3/31/09	Added General Note (F)
DATE	REVISION	
STATE OF HAWAII DEPARTMENT OF TRANSPORTATION HIGHWAYS DIVISION BRIDGE GENERAL NOTES INTERSTATE ROUTE H-1 EXTENSION AND REPAIR OF SCHOOL STREET ON-RAMP RETAINING WALL Project No. H11-01-08 Scale: As Noted Date: Feb., 2009

3/31/09	Revised and/or Added Callouts and Legend
DATE	REVISION
STATE OF HAWAII DEPARTMENT OF TRANSPORTATION HIGHWAYS DIVISION RETAINING WALL REPAIR and EXTENSION EXISTING SITE PLAN INTERSTATE ROUTE H-1 EXTENSION and REPAIR of SCHOOL STREET ON-RAMP RETAINING WALL Project No. H11-01-08	
Scale: As Noted	Date: Feb, 2009
SHEET No. Q3 OF 34 SHEETS

RETAINING WALL REPAIR and EXTENSION

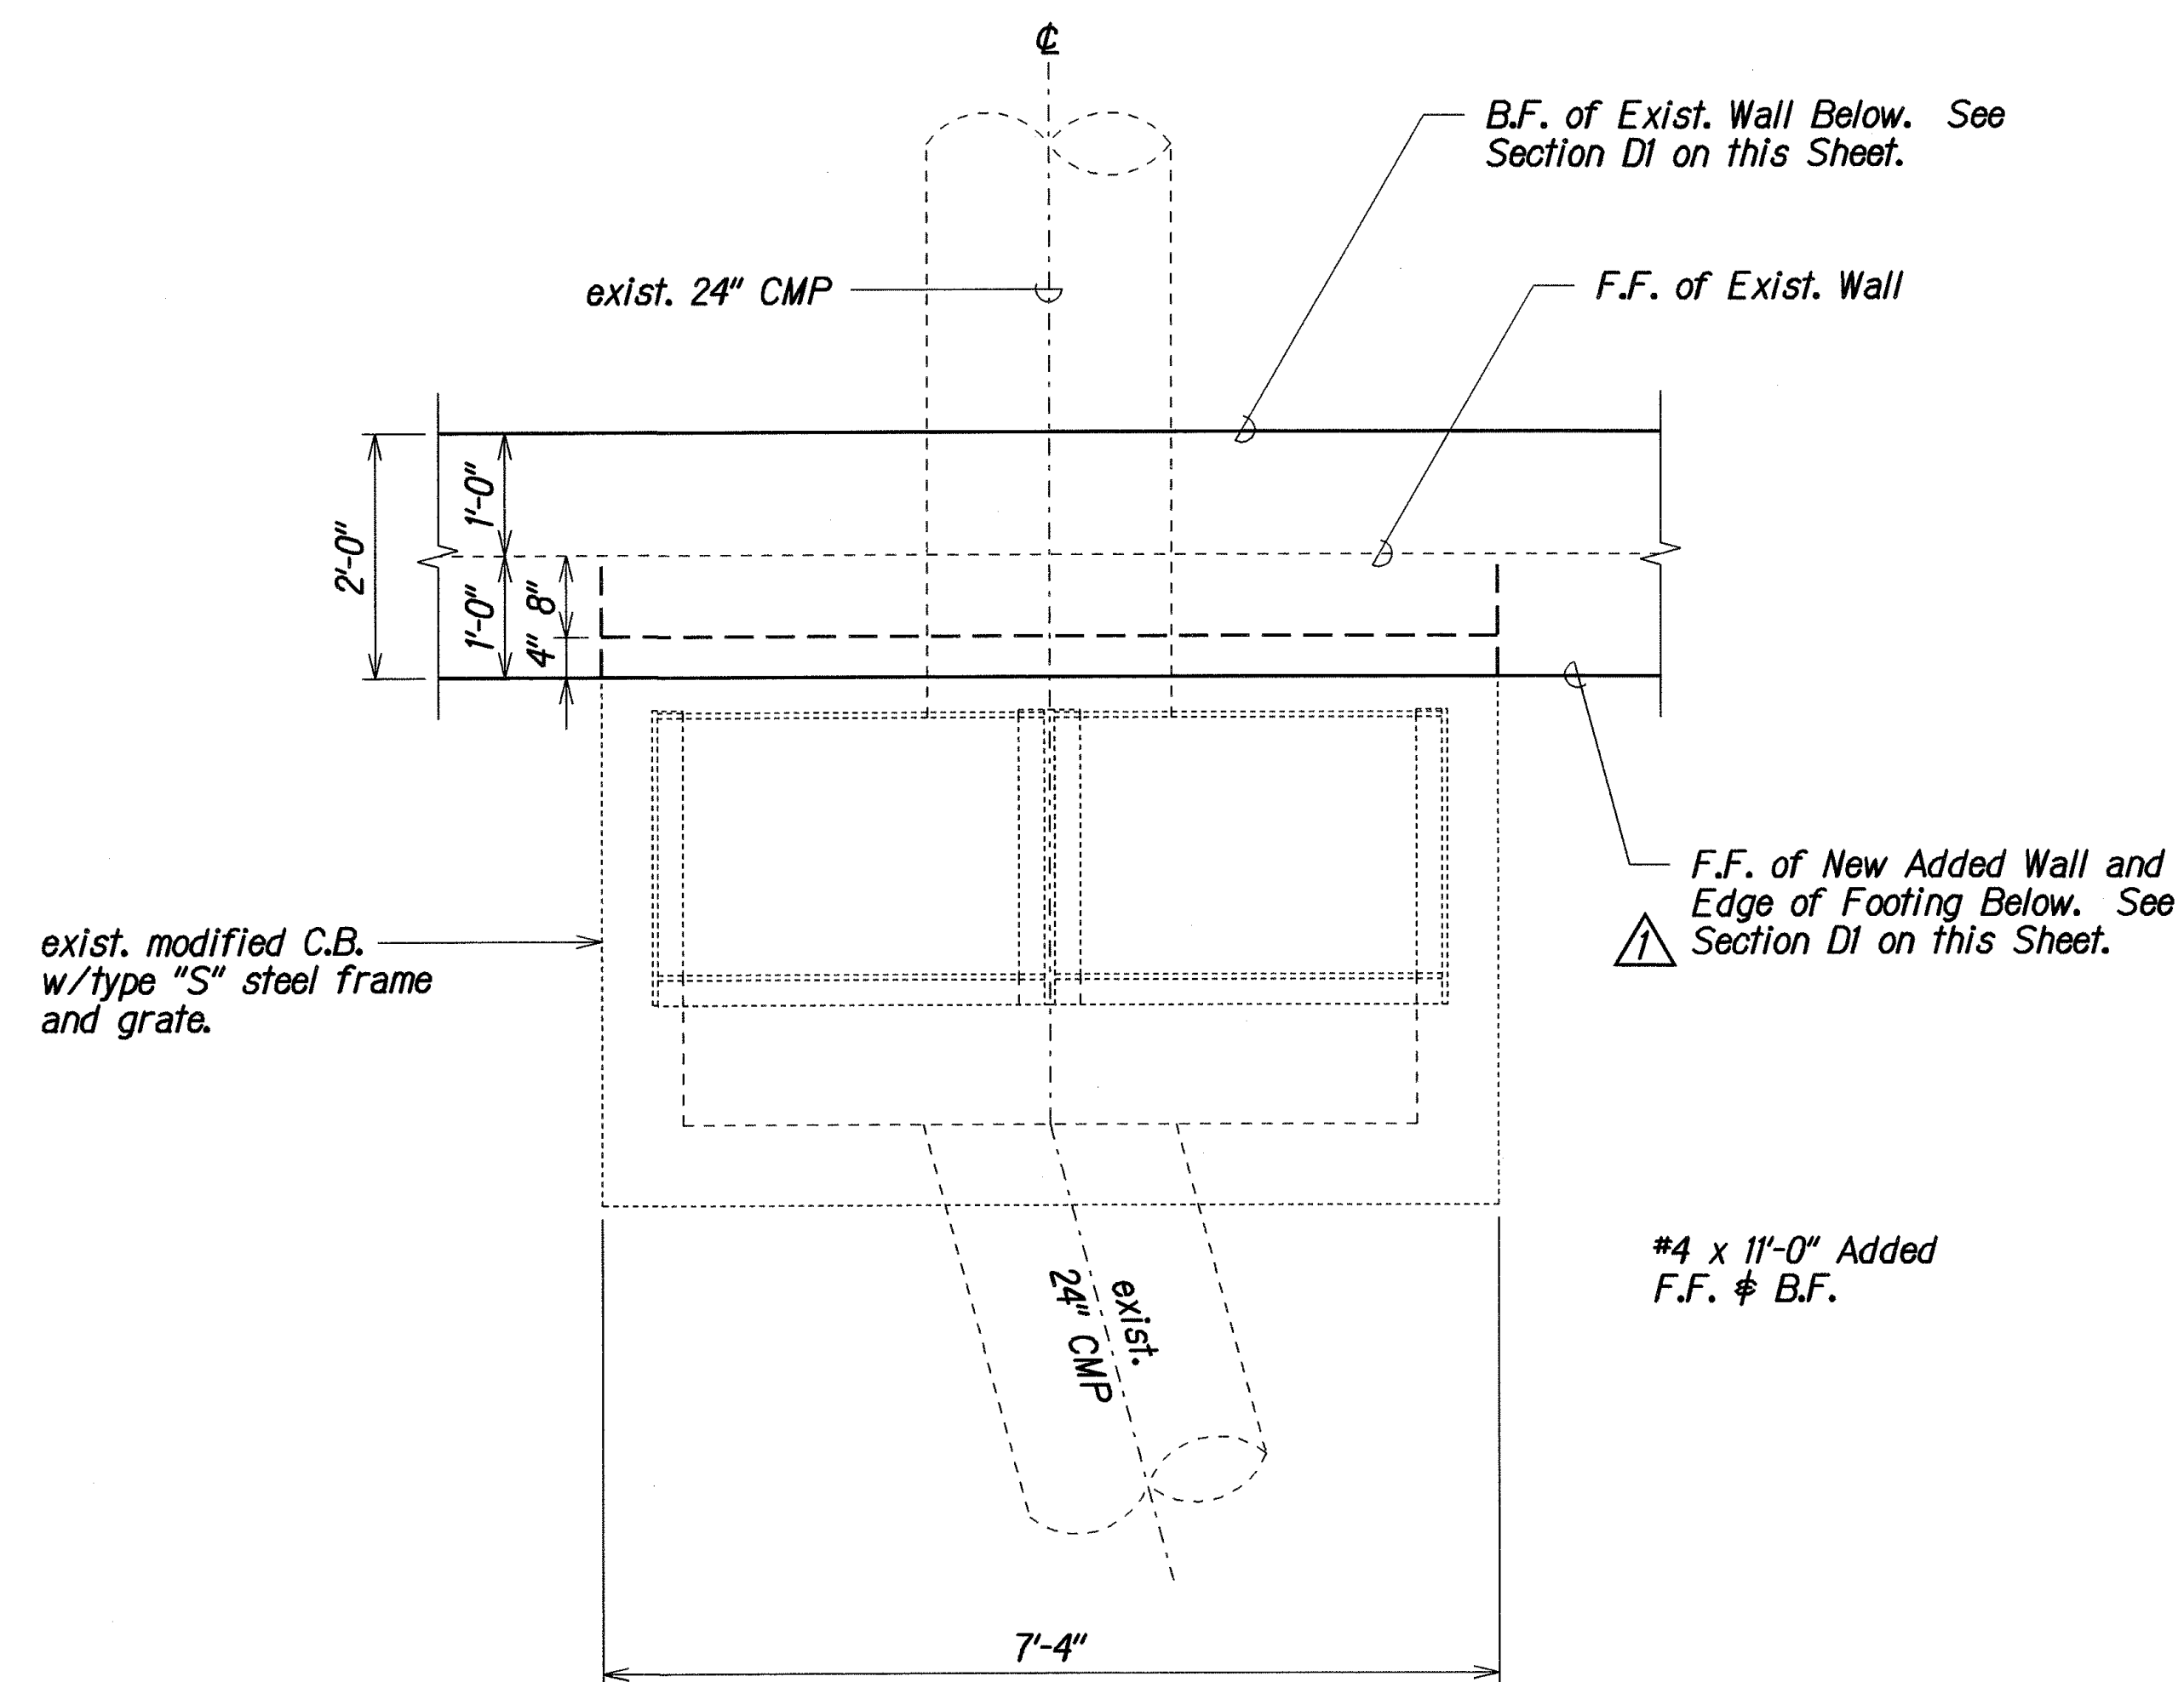
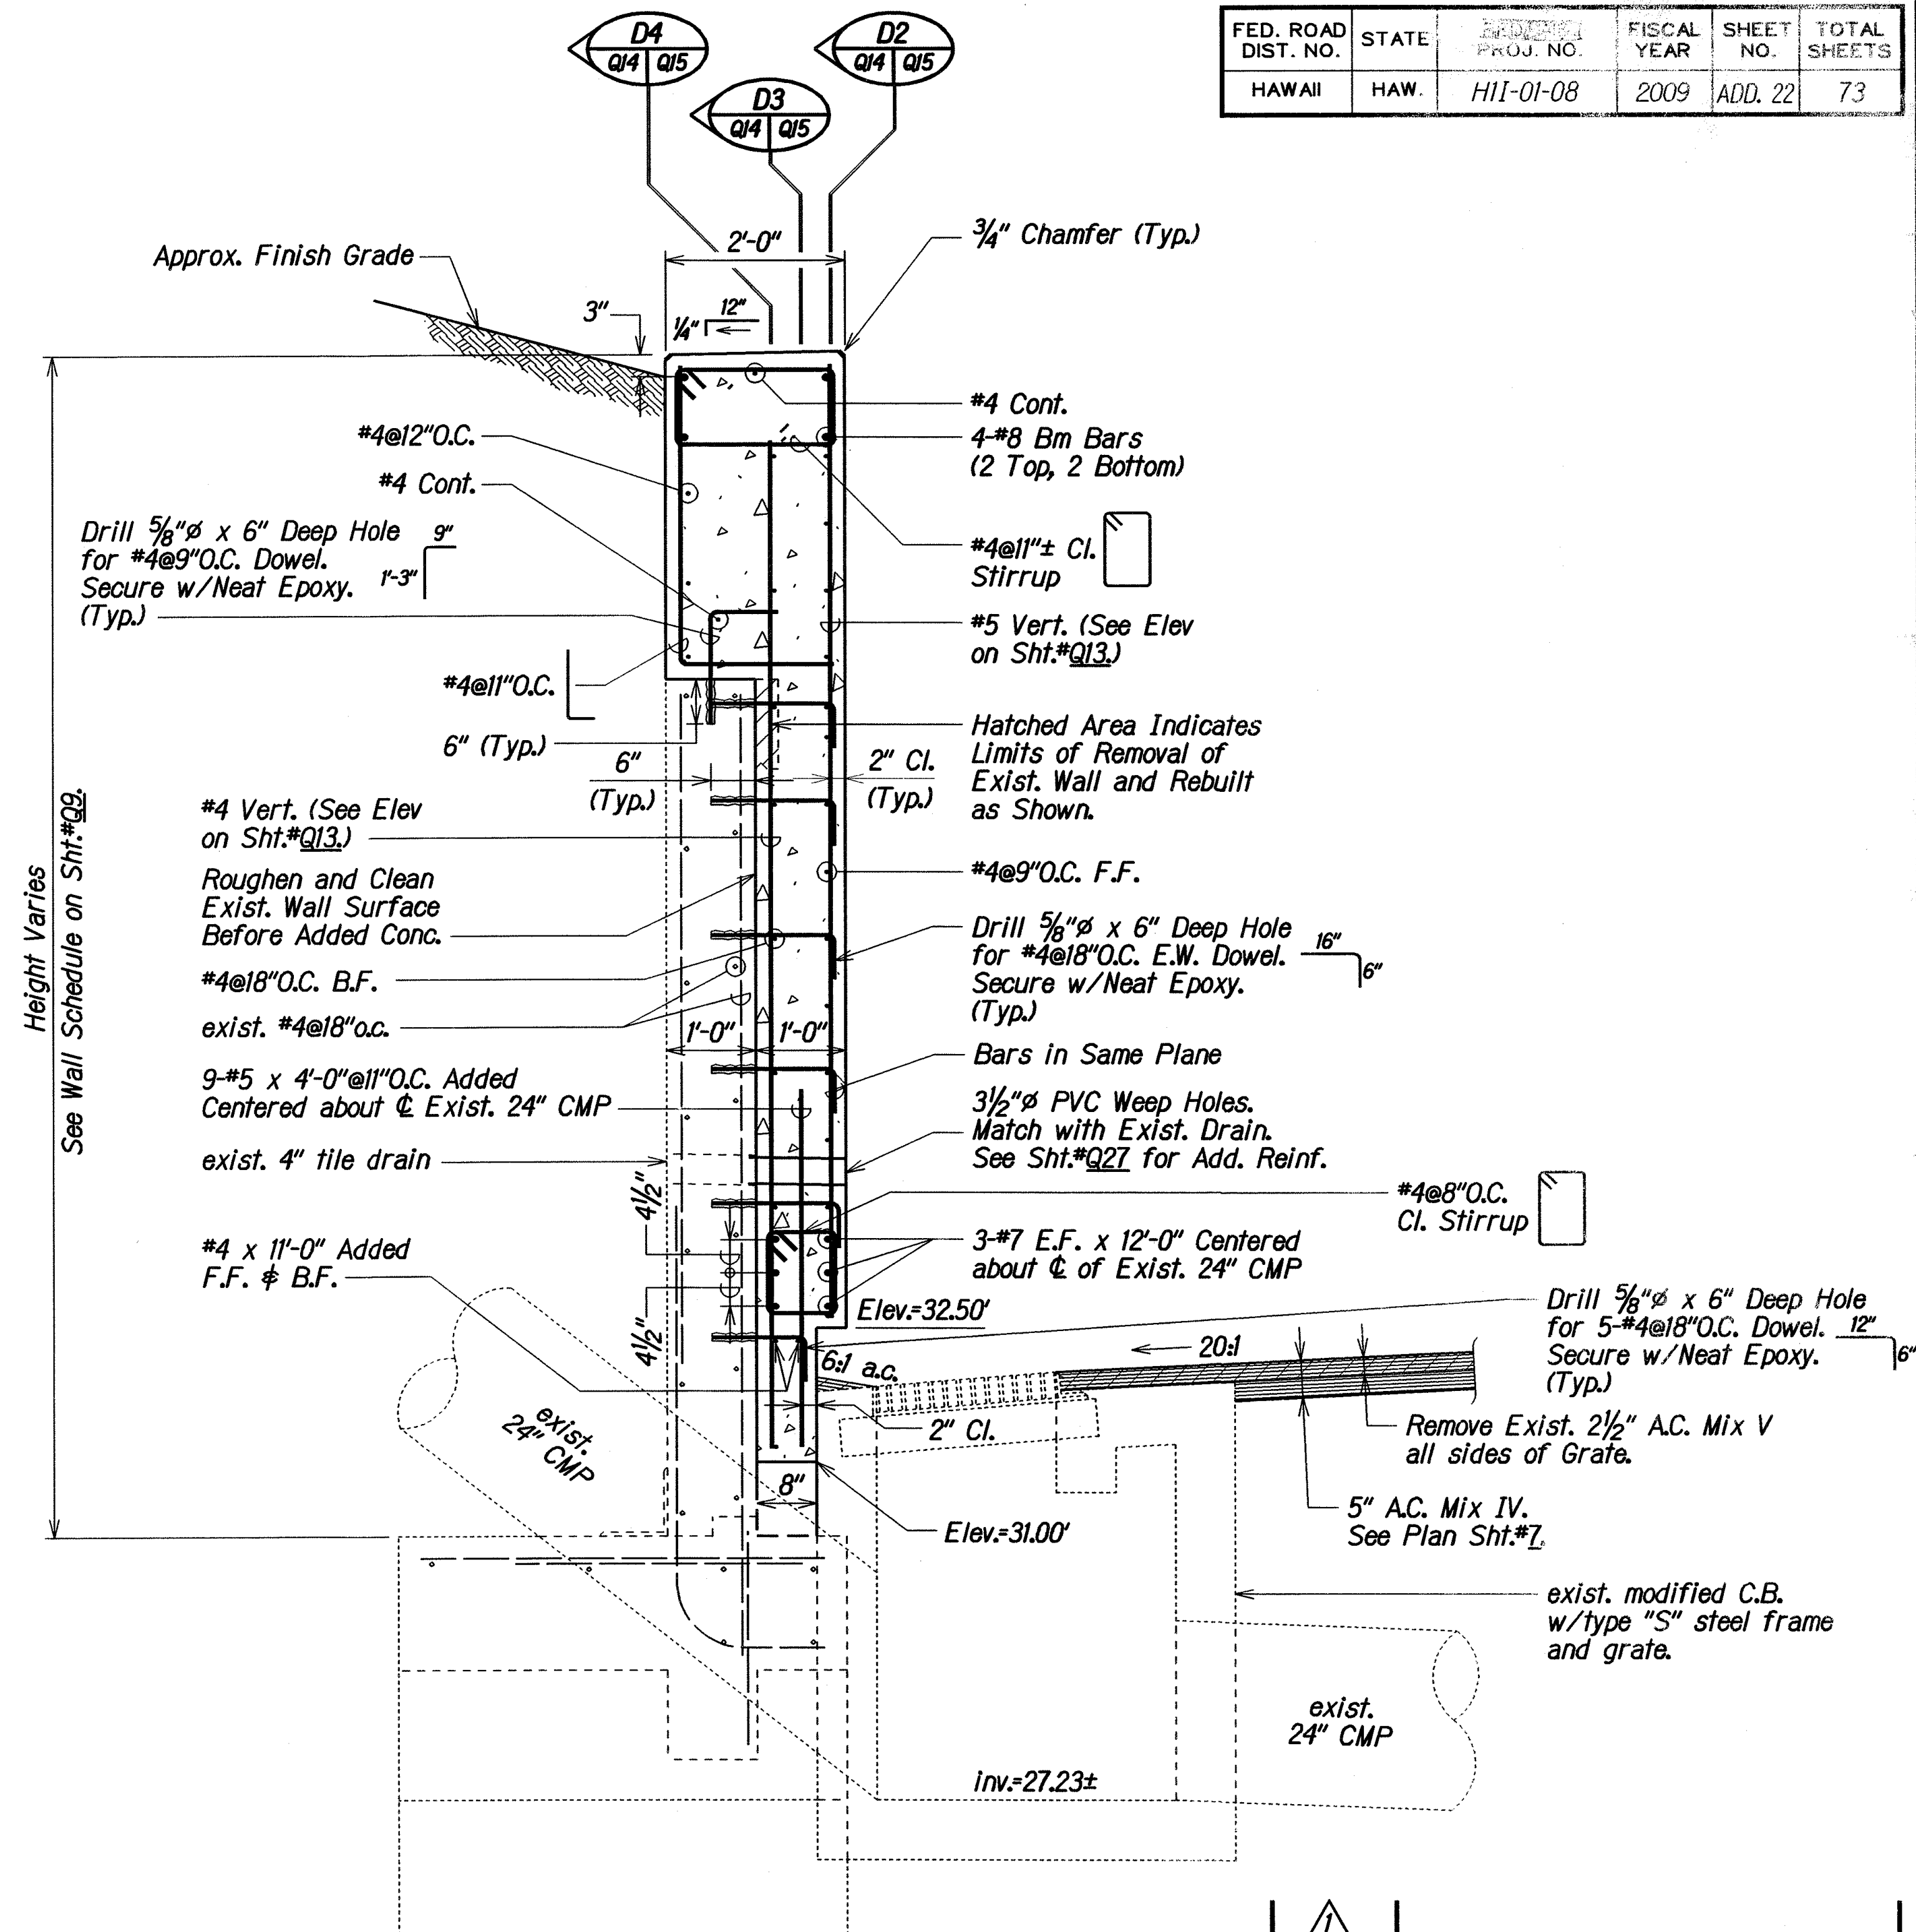
3/31/09	Revised Section Designation
DATE	REVISION
STATE OF HAWAII DEPARTMENT OF TRANSPORTATION HIGHWAYS DIVISION RETAINING WALL REPAIR WALL "G" AT MODIFIED C.B. #64-F PLAN AND SECTION INTERSTATE ROUTE H1 EXTENSION AND REPAIR OF SCHOOL STREET ON-RAMP RETAINING WALL Project No. H11-01-08 Scale: As Noted Date: Feb. 2009	
SHEET No. Q14 OF 34 SHEETS
